Your Ref: ERC0263

Submission: Primary frequency response incentive arrangements

CS Energy welcomes the opportunity to provide a submission to the Australian Energy Market Commission's (**AEMC's**) *Draft rule determination – Primary frequency response incentive arrangements (Draft Determination)*. CS Energy is strongly supportive of ensuring processes such as incentivising the provision of Primary Frequency Response (**PFR**) that are critical to the effective and efficient management of secure and reliable energy now and into the future are agile and fit for purpose.

Figure 1 System frequency measured at Callide B2

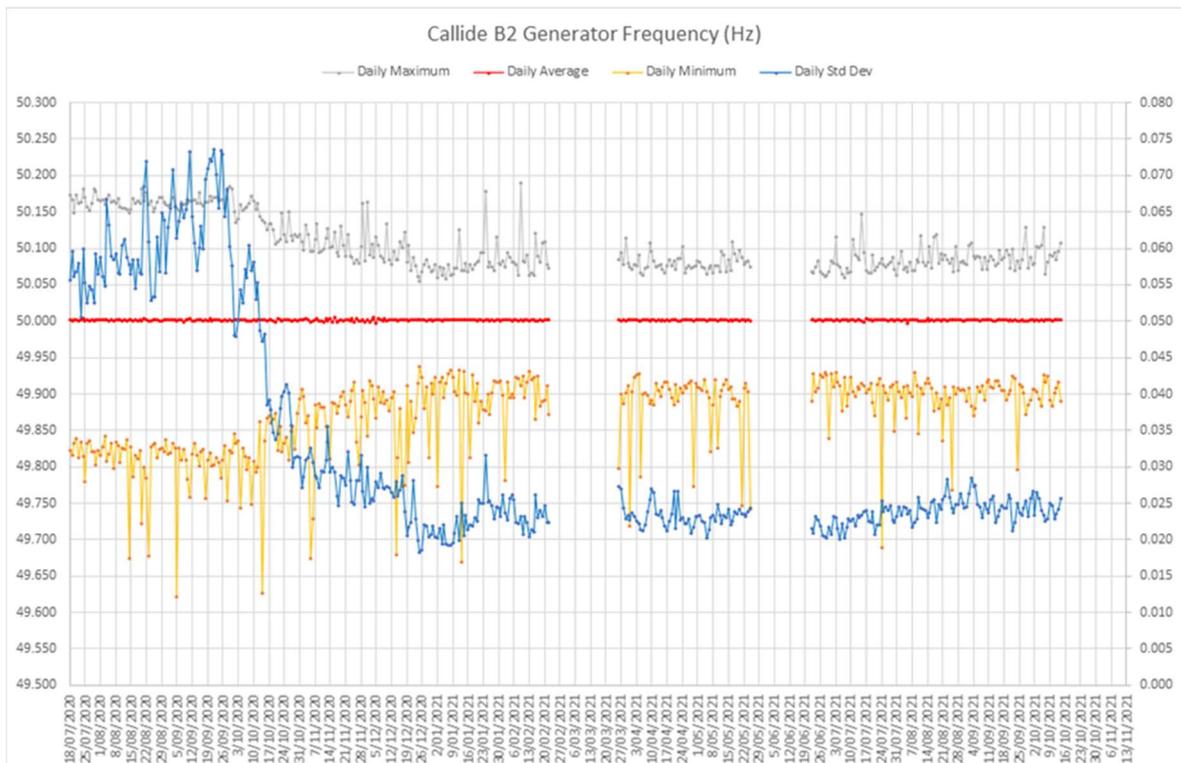
CS Energy disagrees with the advice obtained by the AEMC that the rollout of mandatory narrow-band PFR has been successful and that directly measurable costs of the new obligation on conventional plant appear low. On the contrary, the “same size fits all” approach appears to be heavy-handed with all the improvement in system frequency occurring prior to the completion of the first tranche of governor switching. Figure 1 shows the daily system frequency and standard deviation as measured at Callide B Unit 2 from mid-July 2020 to mid-October 2021, the trend of which clearly showing the improvement in the first month and diminishing returns thereafter.

This suggests that PFR need not be mandatory for the entire capable fleet or at least does not need to be as stringent as a ± 15 mHz deadband. It also suggests that much of the PFR governor response is wasted by counter-action between governors with different response lags and characteristics.

Given the diminishing returns exhibited in Figure 1, CS Energy is concerned that further tranches of mandated PFR have (and will continue to) served only to further contribute to the 18 to 22 second common mode frequency oscillation. This will likely exacerbate the wear and tear on governors, and more high cycle thermal stress fatigue accelerates EOH accumulation on some units. Furthermore, in incentive mechanisms such as a DSCP system, the wasted governor interaction would result in unnecessary higher costs.
